CERTIFICATE OF APPROPRIATENESS STAFF REPORT

SUBJECT: 5711 4th Street South, Case 12-01(B), Carlin Community Hall Historic District

1959 Sanborn Map

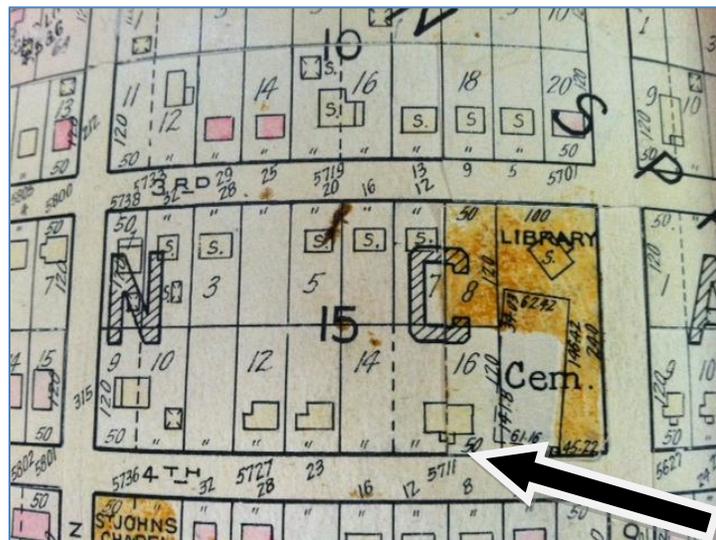
1) Front (Southwest) Porch: The front porch, with its decorative woodwork, is a now-familiar feature of the building. Building permits and historic maps show that it was constructed after 1961, possibly when the County first acquired the building. The 1959 Sanborn Fire Insurance map and the 1961 Franklin Atlas of Arlington County do not show this porch (see the next page for images of the maps). Though useful, the porch has some anachronistic features including applied stone on the front steps and posts that obscure direct passage to and from the front door. Reverting to the original condition of the building, with no porch, is not desirable as there is no protection from the elements, nor is it warranted. A covered front porch is an amenity for this community building and staff agrees that it should be retained in some form.
